**E-Mail Notice from John Richards with  
Residential Plan Review, sent on 10/26/2020  
(work was stopped immediately upon  
receipt)**

**Revision to Garage Remodel Plans  
to change back wall to masonry  
due to access blocked by neighbor's fence**

# BIELAMOWICZ RESIDENCE GARAGE RENOVATION

**ISSUED FOR REVISION #1 - OCTOBER 26, 2020**

# A-101-A

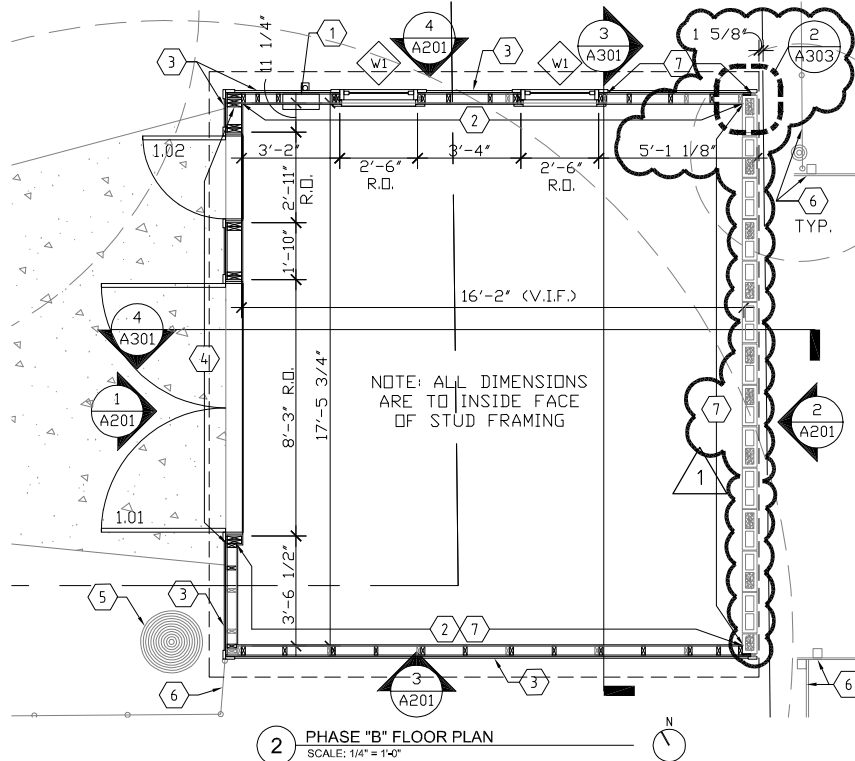
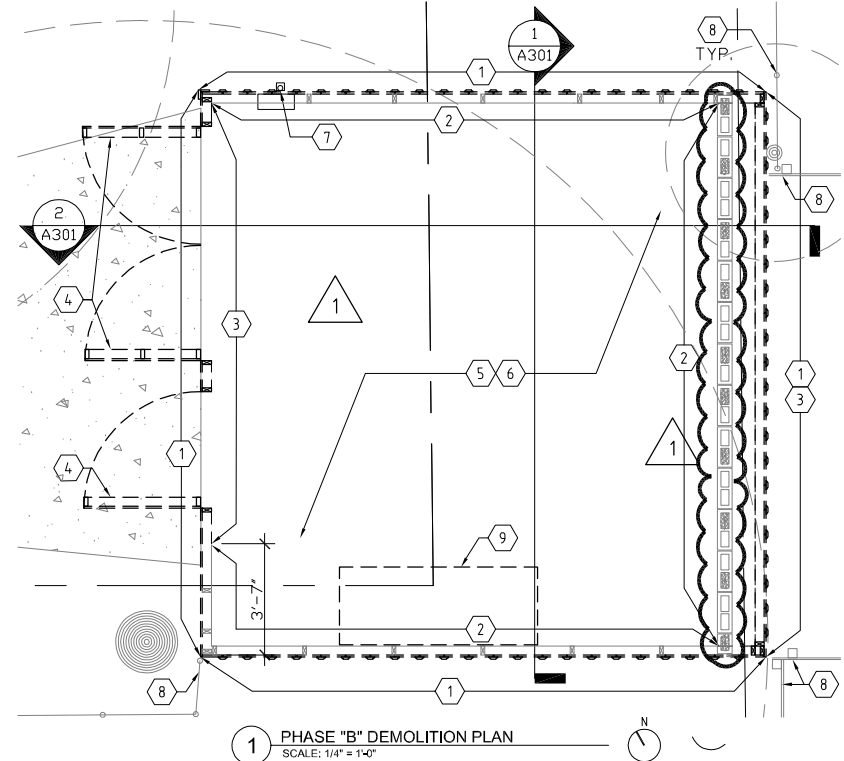
- ① NEW 6" CMU WALL. WALL TO BE MIN. 1-HR FIRE RATED PER UL U906. BLOCKS TO BE TYPE D2. GROUT EVERY 3RD CELL W/ #4 BAR.
- ② PROVIDE ADD'L 2x4 STUDS IN EXISTING WALL AS NEEDED. FASTEN NEW WALL TO EXISTING WALL PER IRC TABLE R602.3(1) FASTENING SCHEDULE, LINE 9.

- ① NEW ELEC SUB-PANEL. RE: E-101
  - ② PROVIDE ADD'L 2x4 STUDS TO ACHIEVE SPACING OF 16" O.C. AND FRAME NEW OPENINGS, RE: FRAMING DETAIL 5/A501
  - ③ PROVIDE SHEATHING, HOUSE WRAP, LAP SIDING, AND STUCCO SKIRT, ALL 4 WALLS. RE: ELEVS ON A-201 & SECTIONS ON A-301.
  - ④ 2x6 STUD FRAMING, RE: DETAIL 6/A501
  - ⑤ PROTECT EXISTING OAK TREE FROM DAMAGE.
  - ⑥ EXISTING FENCE TO REMAIN
  - ⑦ WALLS WITHIN 5' OF PROPERTY LINE TO BE 1-HR FIRE RATED PER INTERTEK JH/FCS 60-04, OR UL U906 FOR CMU WALL.
- ALL WOOD FRAMING TO BE BUILT IN ACCORDANCE WITH THE PRESCRIPTIVE REQUIREMENTS OF THE 2015 IRC
